**ITEM 4. DEVELOPMENT APPLICATION: 312 AND 314-318 GEORGE STREET SYDNEY****FILE NO: D/2017/337****DEVELOPMENT APPLICATION NO: D/2017/337****SUMMARY**

**Proposal Summary:** Demolition of the existing buildings and construction of a new 17 storey building comprising hotel bar, plant, storage and commercial uses at basement level, commercial and hotel uses at ground level and level 1, hotel uses at levels 2-16 (the hotel comprises 195 rooms) and a signage strategy.

The development application is recommended for deferred development consent.

**Figure 28:** Agreed design changes to basement level to address flood risks prior to design amendments.

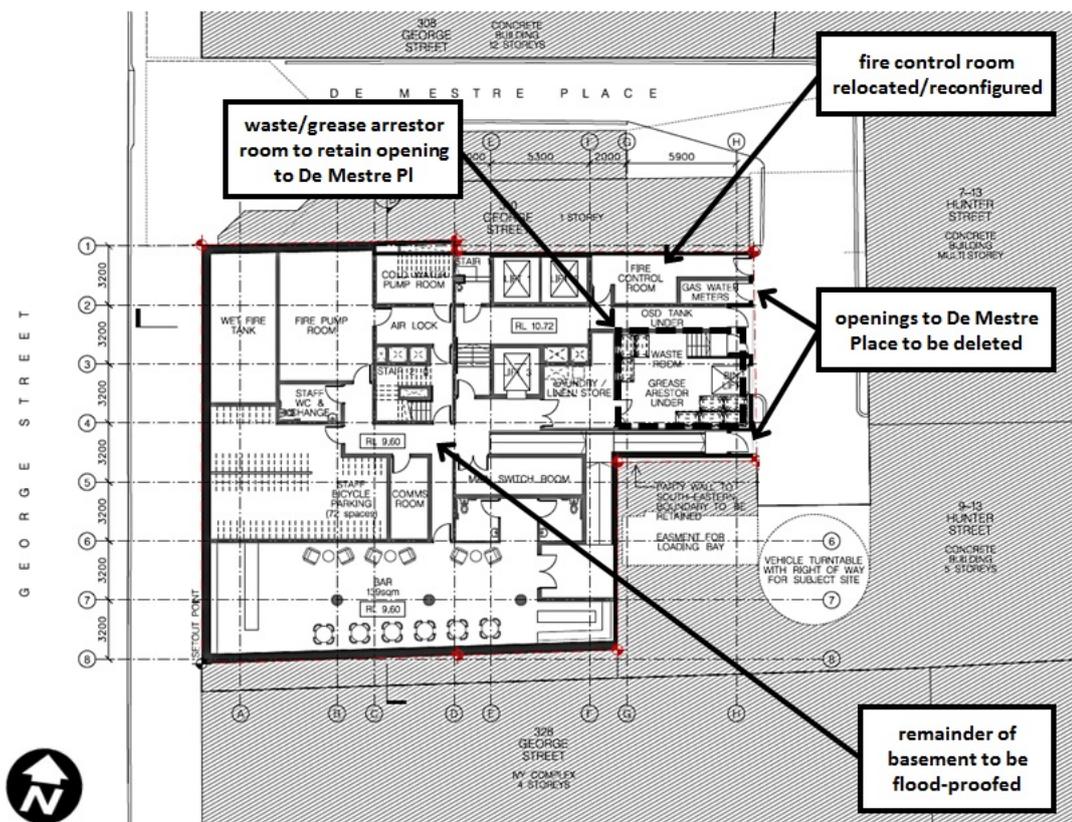
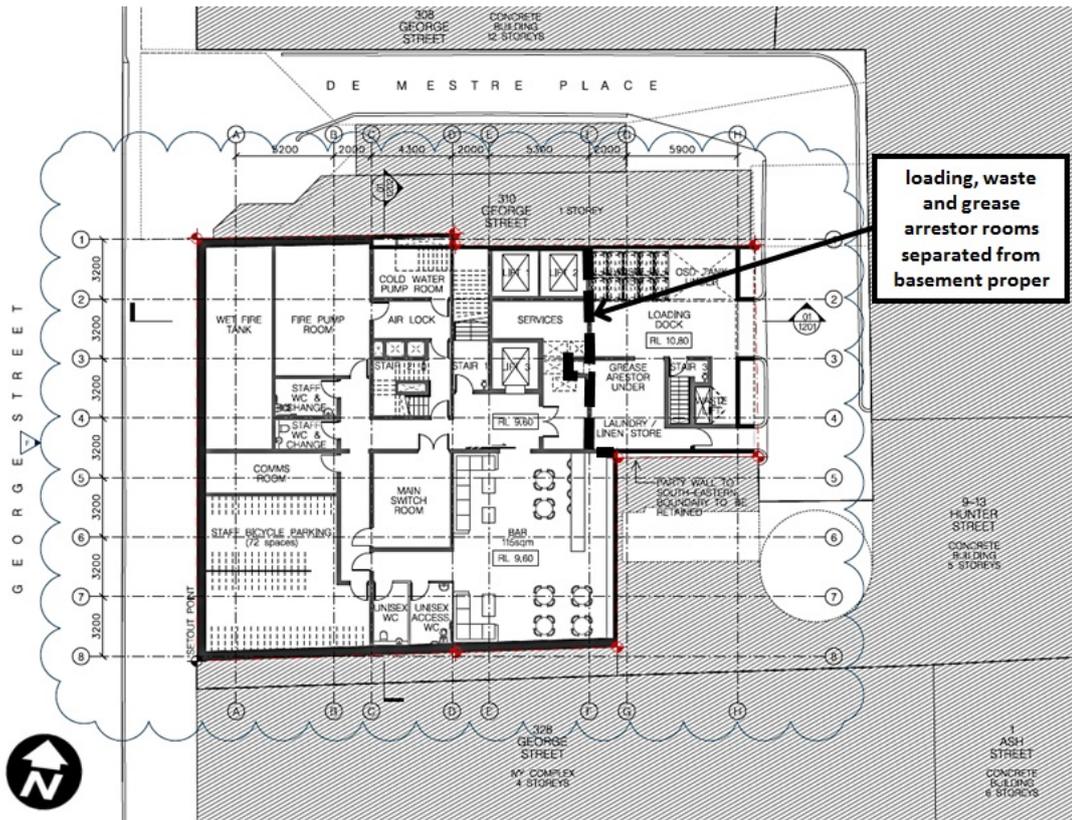
58. Council's flood engineers and planning officers met with the applicant's consultants on 20 September 2017 to discuss flooding issues and where key design changes required to address the site's flood risk were agreed upon (refer to **Figures 28 and 30** below).

- (a) proposed bar reconfigured to allow access from hotel lobby (RL 14.20);
- (b) on-site loading dock included to accommodate Small Rigid Vehicle (SRV);
- (c) fire control room relocated to the ground (George Street) level (RL 14.20);
- (d) proposed loading dock, waste and grease arrestor rooms accessed from De Mestre Place have been isolated from the basement proper to prevent flood ingress;
- (e) stair 3 introduced to provide a fire isolated escape route to George Street for the proposed loading dock, waste and grease arrestor rooms accessed from De Mestre Place;

Figure 29: Final amended basement level incorporating agreed changes.

Figure 30: Agreed design changes to ground level to address flood risks to address flood risks prior to design amendments.

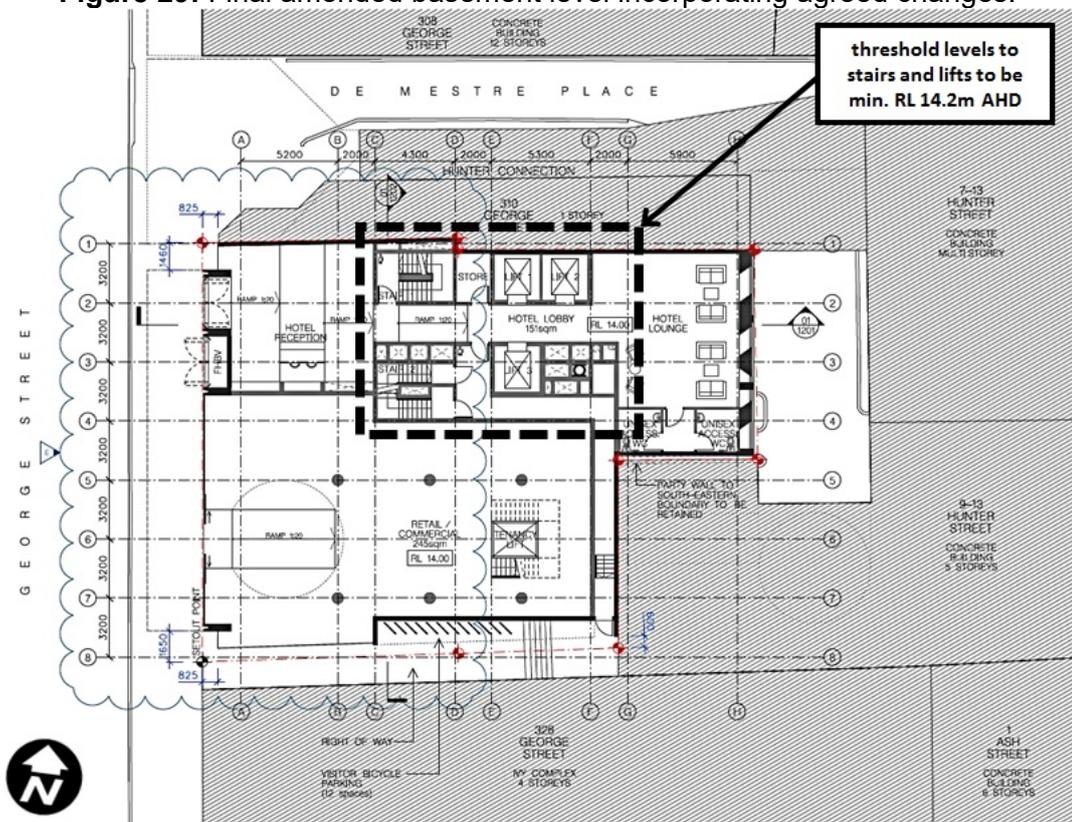
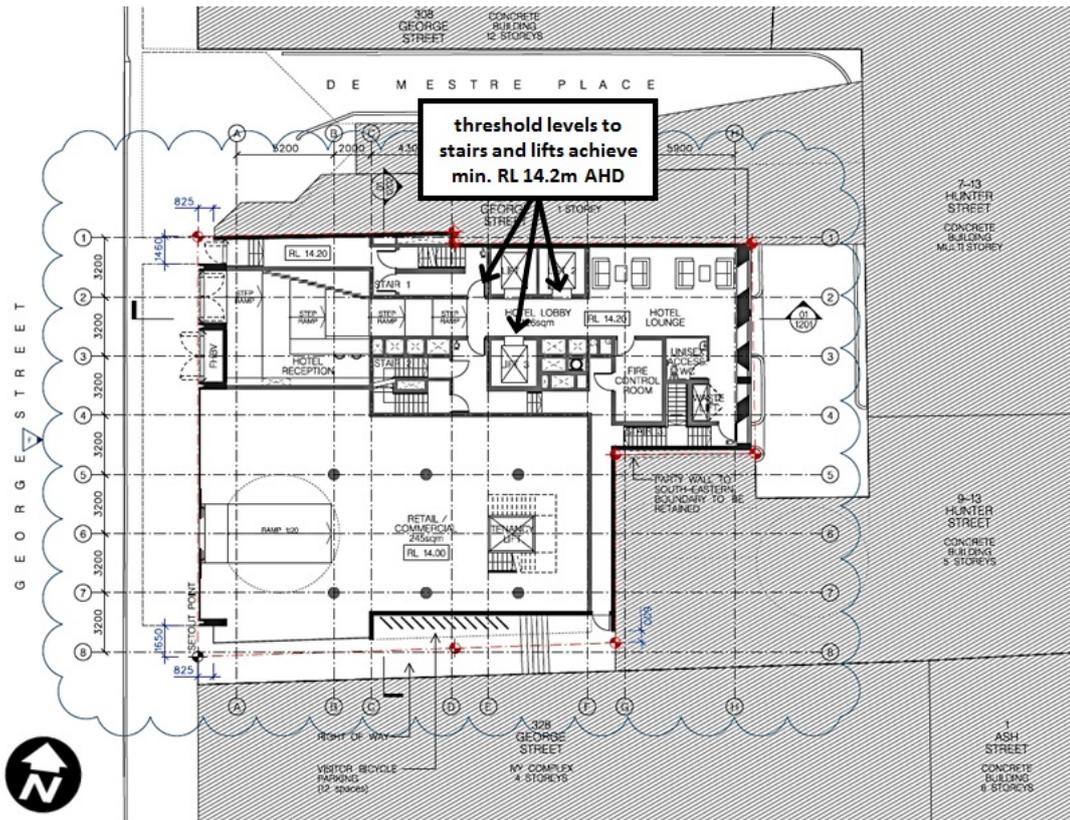
- (f) ground floor level in the George Street commercial tenancy has been elevated to RL 14.00; and
  - (g) thresholds to lifts and stairs within the hotel ground floor lobby have been elevated to RL 14.20.
60. The amended plans incorporating design modifications described at paragraph 59 above are considered to address flood risks and are illustrated in **Figures 29** and **31** below.

Figure 31: Final amended ground level incorporating agreed changes.

**Figure 32:** S1 as shown in the signage strategy.

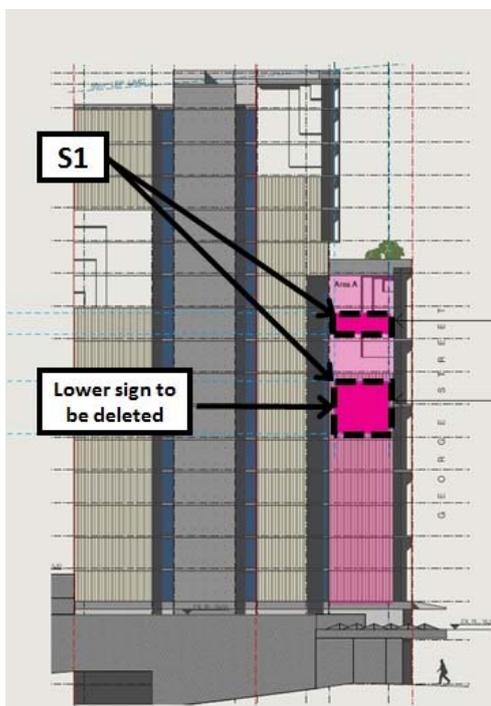
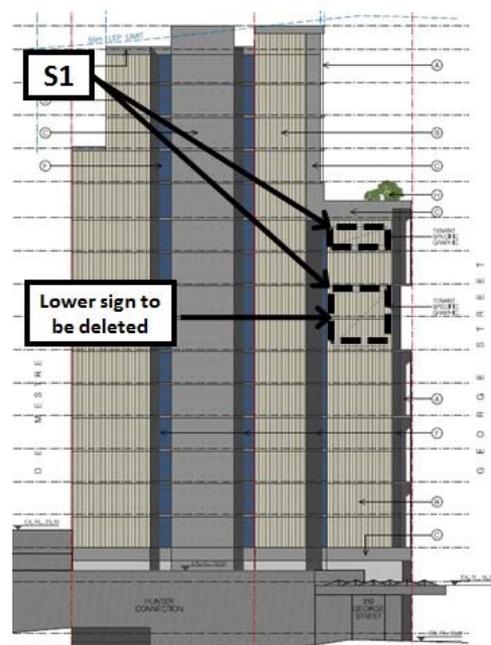
63. The two proposed top of building signs identified as S1 in the signage strategy are shown in **Figures 32** and **33** below. DCP provision 3.16.5.2 permits only a single top of building sign per elevation, to be allocated to the significant tenant of the building. Top of building signs are to be limited in height to only one floor of the building.

64. Conditions are recommended for design modifications to the building and to the signage strategy for a single top of building sign to be associated with the hotel use, and in accordance with the design requirements at DCP provision 3.16.5.2.

**Figure 36:** S4 as shown in the signage strategy.

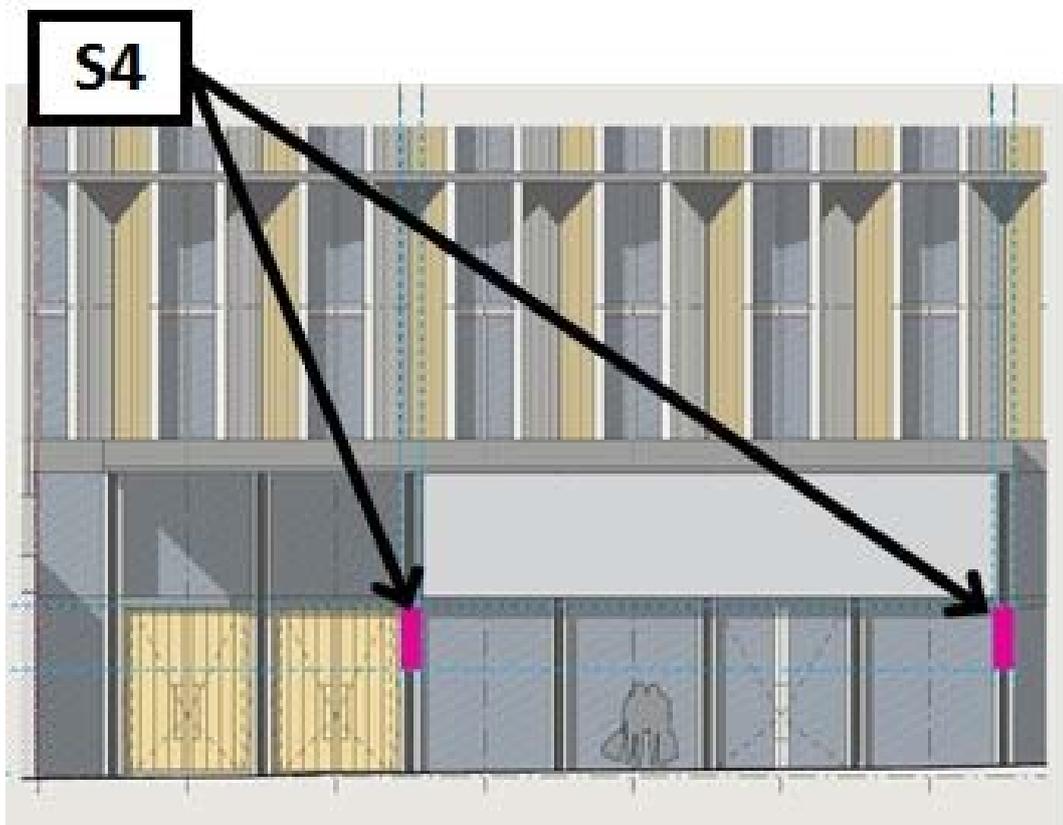
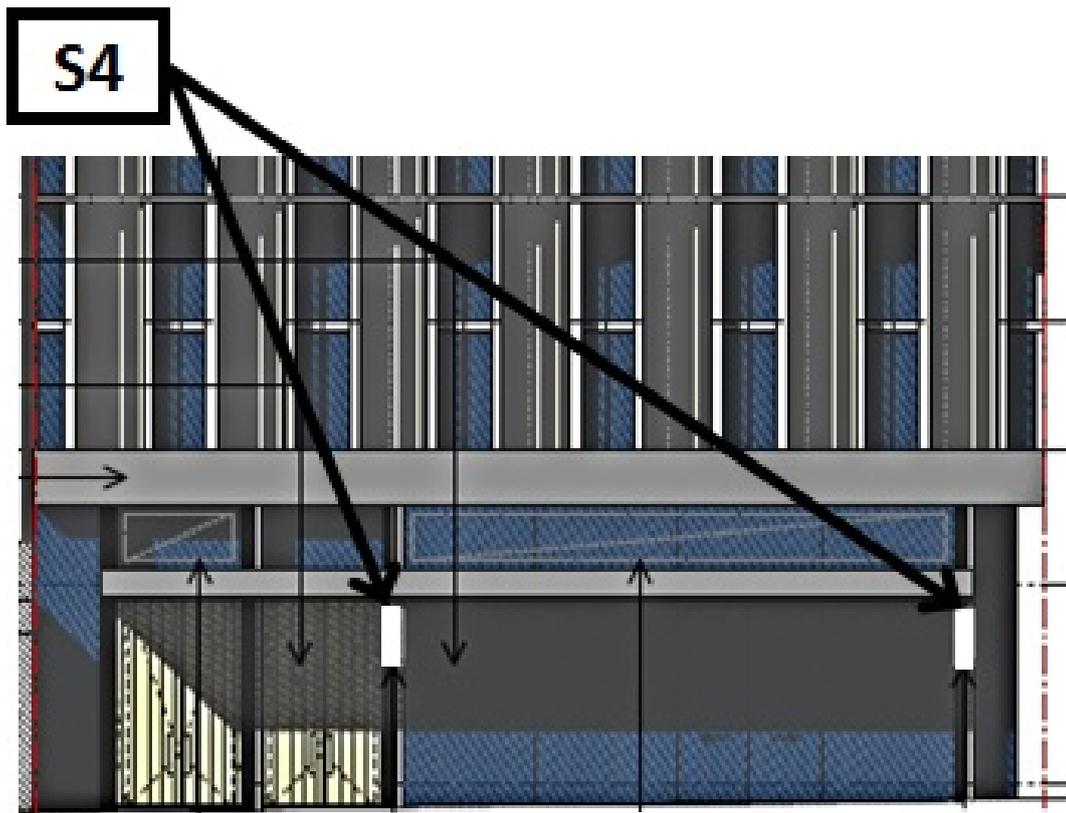
69. The two flat-mounted wall signs associated with the commercial tenancy identified as S4 in the signage strategy, are shown in **Figures 36** and **37** below. In accordance with DCP provisions 3.16.3(5) and 3.16.6.1(1) which require that signage should not create visual clutter and due to the number of signs proposed, it is considered that signs S4 are unnecessary and give rise to visual clutter, and are not supported.

Figure 38: S5 as shown in signage strategy.

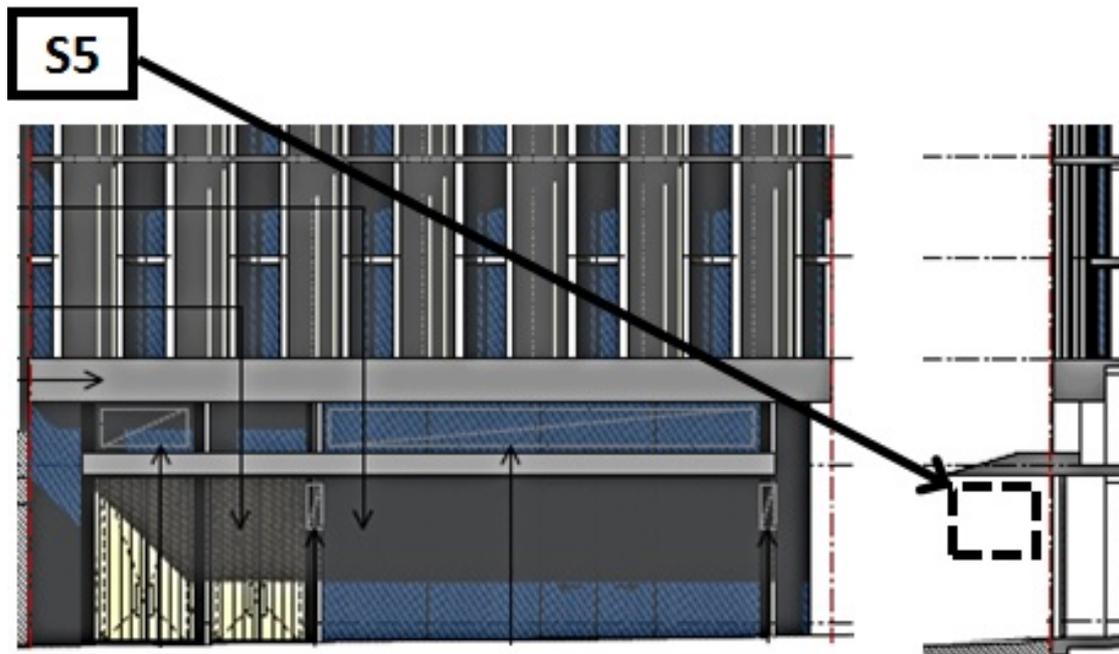
70. The two under-awning signs associated with the commercial tenancy and identified as S5 in the signage strategy are shown in **Figures 38** and **39** below. The under-awning signs in the elevation at **Figure 39** below are not clearly differentiated from flat mounted signs identified as S4 in **Figure 37** above.

71. The under awning signs are to be associated with the commercial tenancy (shown in **Figure 39** above) and are supported.
72. Conditions are recommended to clarify discrepancies between the signage strategy and the architectural drawings and to ensure the approved signage strategy is consistent with DCP provisions pertaining to materiality, illumination, size and clearance above footpaths.

**Figure 40:** Nil setback from level 12 balcony to north and south boundaries.

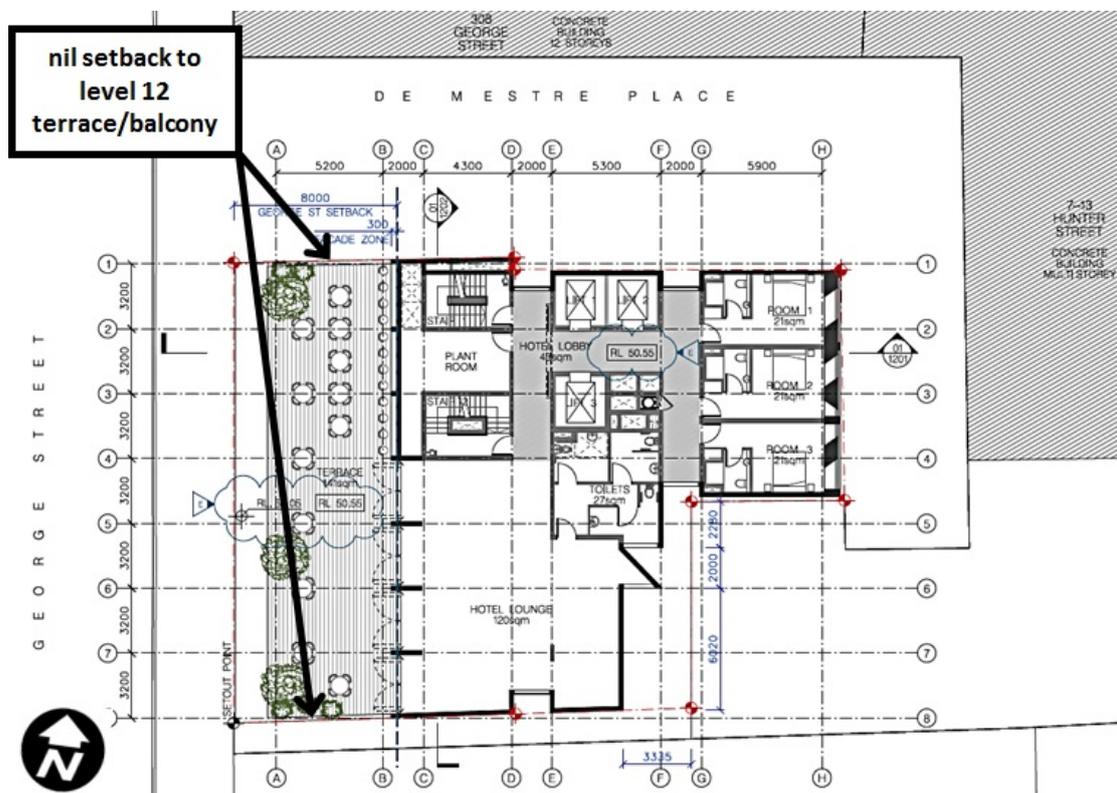
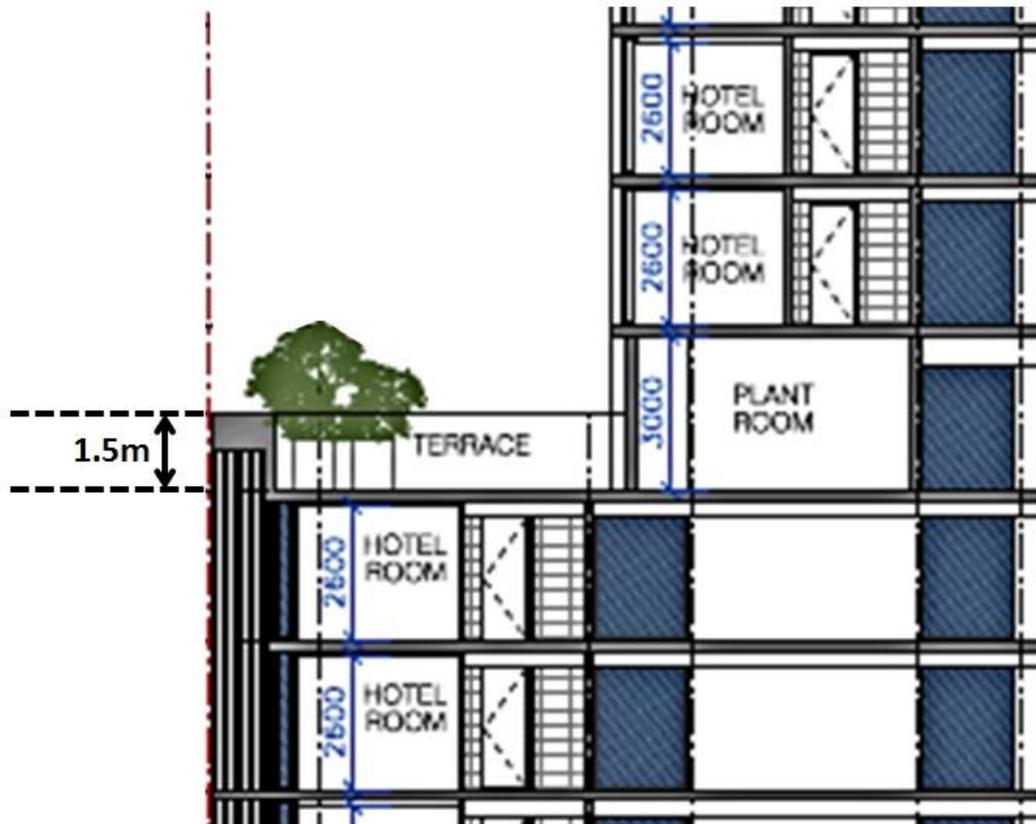
78. As shown in **Figures 40** and **41** below, the proposal provides nil setback from the level 12 terrace/balcony to the north and south side boundaries. A variation is supported in this instance because there is a solid balustrade to the north and south edges of the terrace/balcony to a height of approximately 1.5m and which will provide adequate privacy to and from the terrace/balcony.
79. It is noted that as the level 12 terrace/balcony is enclosed by a balustrade greater than 1.4m, it is gross floor area (GFA) as defined in the LEP and which has been included in the calculation of FSR discussed elsewhere in this report.

Figure 42: Windows facing side boundaries.

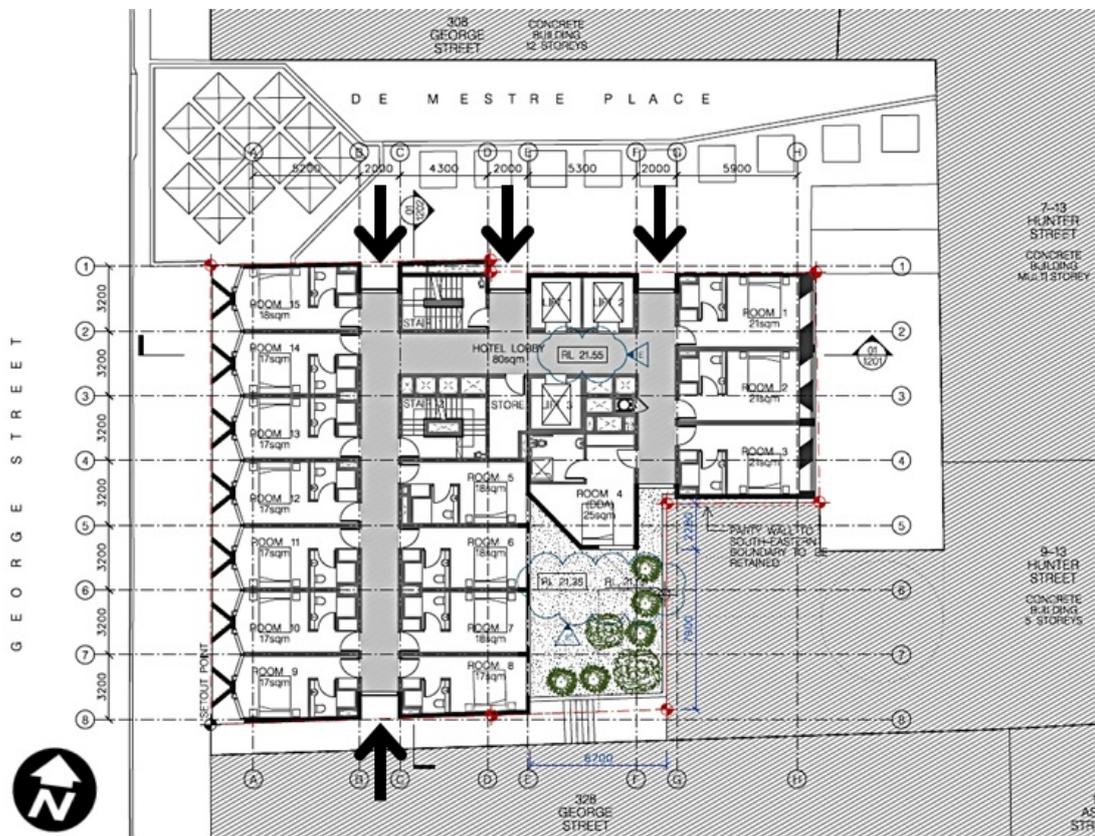
80. As shown in **Figure 42** above, the proposal provides windows to the north and south boundaries that are setback less than 1m from the north and south side boundaries within shallow recesses in these facades.
81. A variation is supported in this instance as the windows are to non-habitable circulation spaces, with the exception of the window to the southern boundary from the level 12 hotel lounge. These windows borrow amenity from the adjacent sites and have no right to that amenity.
82. A condition has been recommended to clarify and advise the landowner and developer that the windows that face side boundaries do not preclude development of the adjacent sites that might have adverse impacts upon the amenity obtained from those windows.
